Traffic
UPDATE

RE: Ritz Carlton Traffic Impact Analysis Resubmittal Summary

RE: Lee Engineering Review of the Ritz Carlton Resort Traffic Impact Analysis (TIA) by CivTech dated August, 2015 – 2nd submittal

**Ritz Carlton
2nd Submittal**

Figure 29: Future Lane Configurations and Traffic Controls A

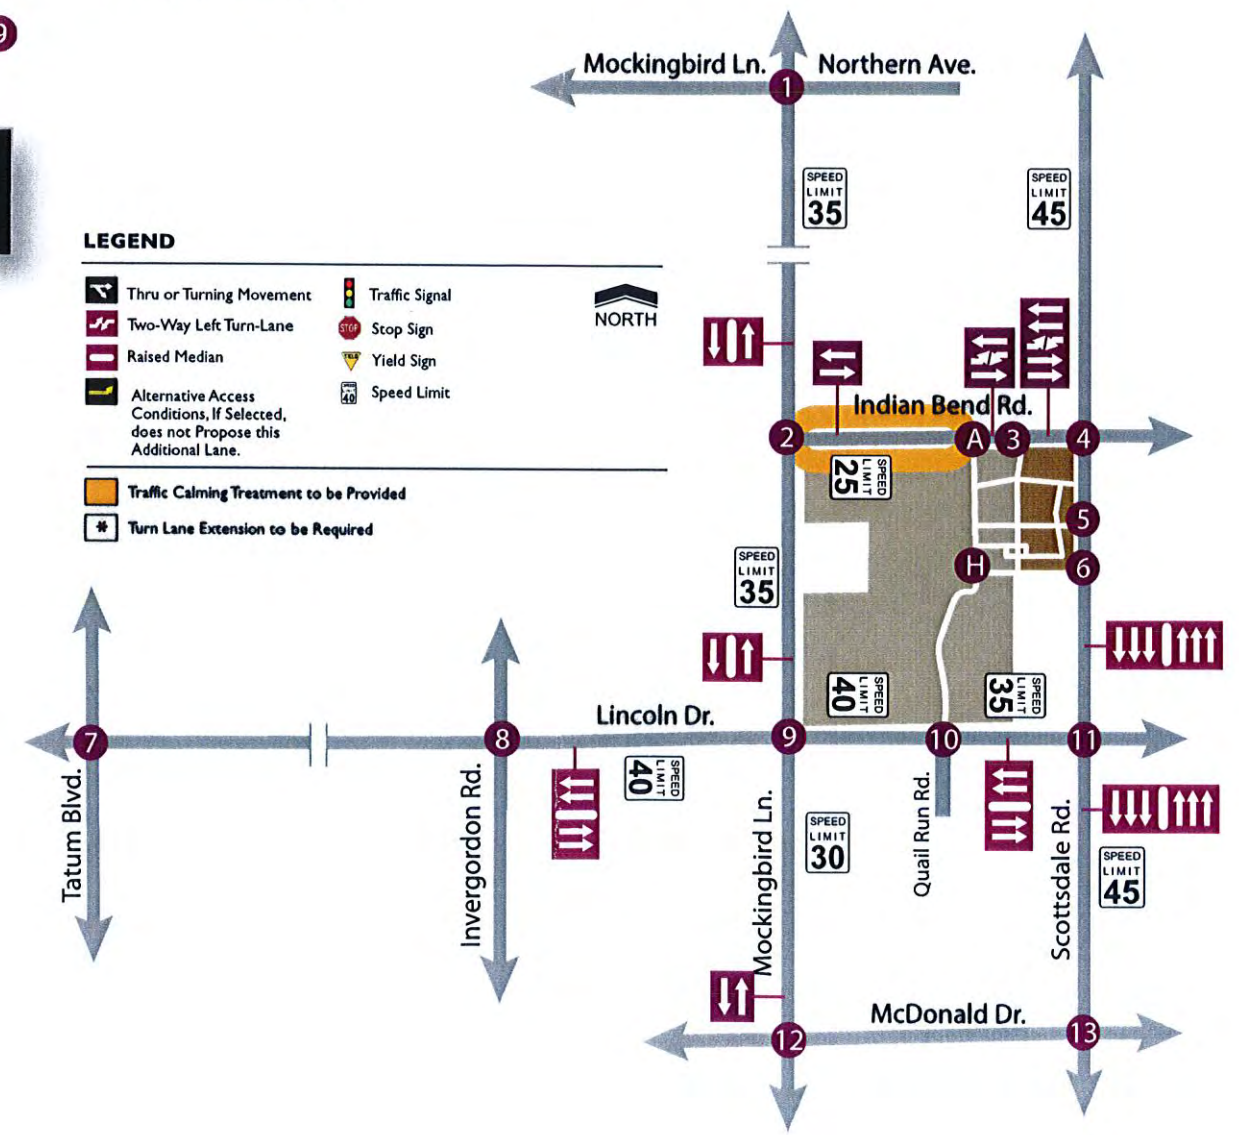
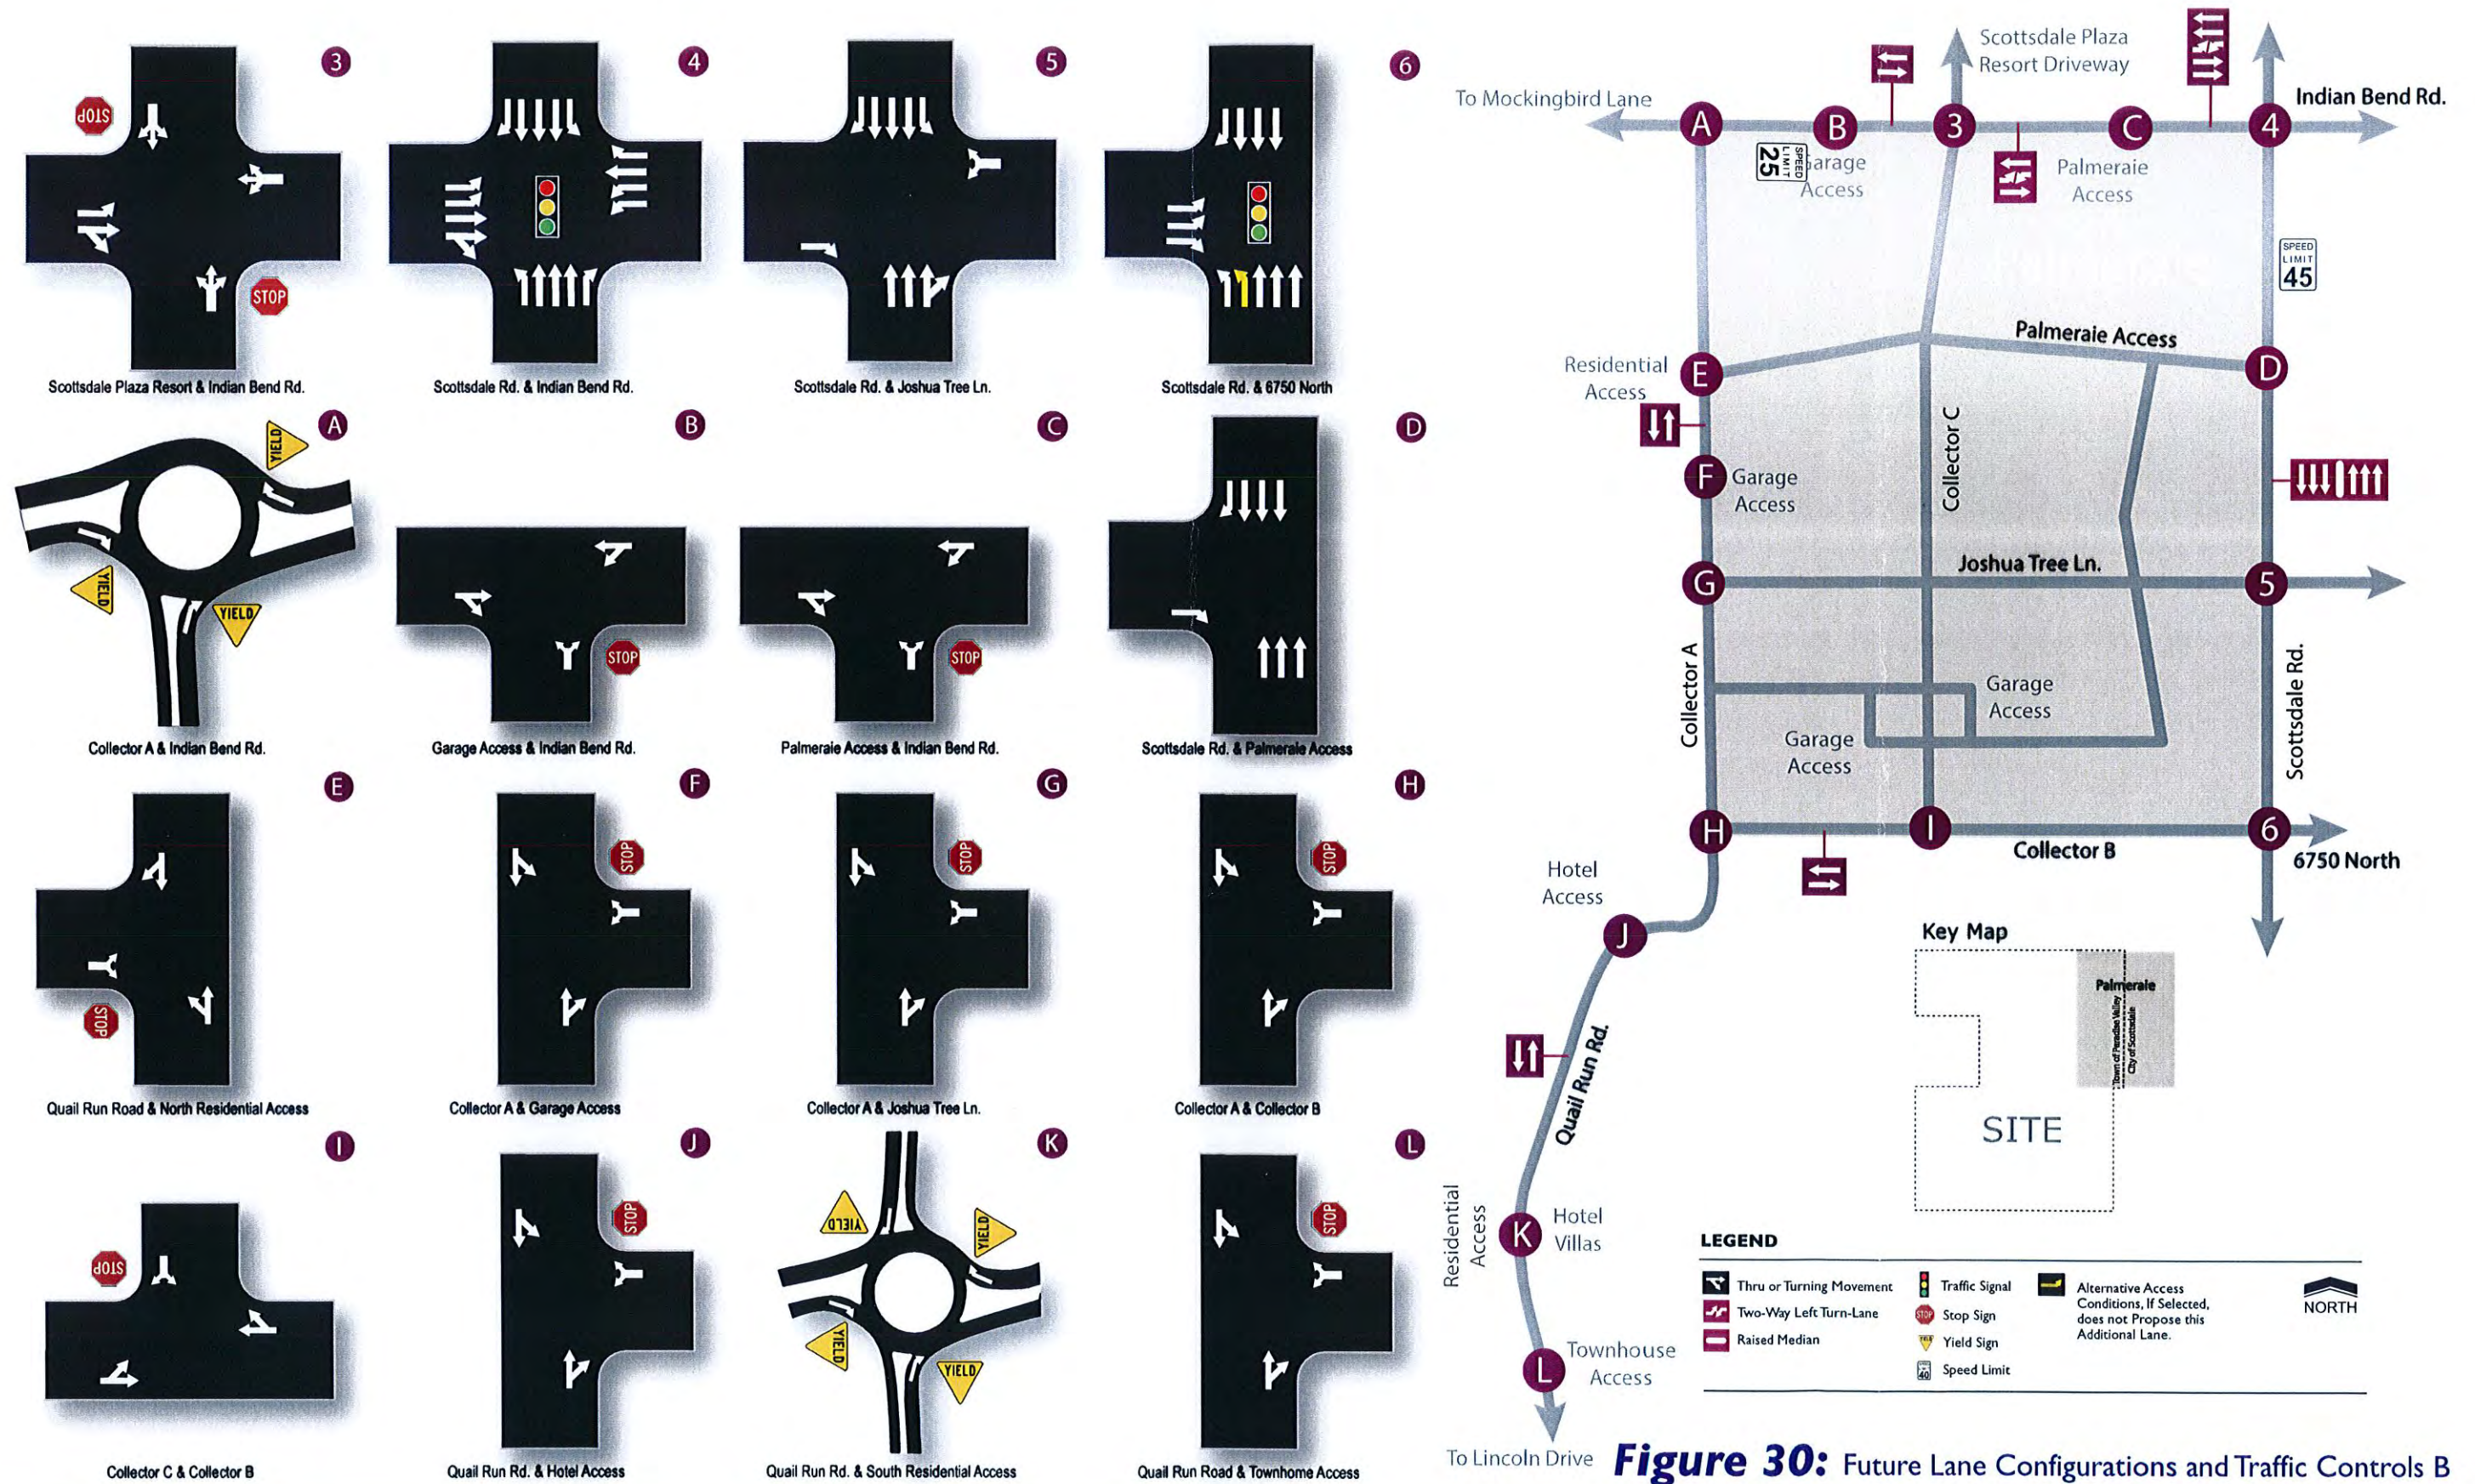
7. Any half-street improvements to the eastbound Indian Bend Road approach to Scottsdale Road should include the mitigation identified in the report (Figure 29) as well as considering any secondary improvement for increasing the northbound left-turn storage or capacity, if required, based on additional analysis at the Scottsdale Road/6750 North intersection.

7.	Paul Guzak- Lee Engineering	Figure 29 (p. 58)	1	Any half-street improvements to the eastbound Indian Bend Road approach to Scottsdale Road should include the mitigation identified in the report (Figure 29) as well as considering any secondary improvement for increasing the northbound left-turn storage or capacity, if required, based on additional analysis at the Scottsdale Road/6750 North intersection.	This intersection will be reviewed again by the City of Scottsdale with the Palmeraie TIMA and mitigation will need to be determined by both the Town of Paradise Valley and the City of Scottsdale. A statement has been added to the TIA. Agree: The eastbound approach should provide dual left-turn lanes, one (1) through lane and a shared through/right-turn lane. A second westbound through lane may be required if dual northbound turn lanes are required by the City of Scottsdale. Mitigation improvements at the intersection of Indian Bend/Scottsdale Road should meet City of Scottsdale design standards which will be determined during the review of the Palmeraie TIA.

7.	John Bartlett & Phillip Kercher			A Southbound right-turn lane should be provided at the intersection of Scottsdale Road and Indian Bend Road.	The report text and Figure 29 have been updated to include SB the right-turn lane.
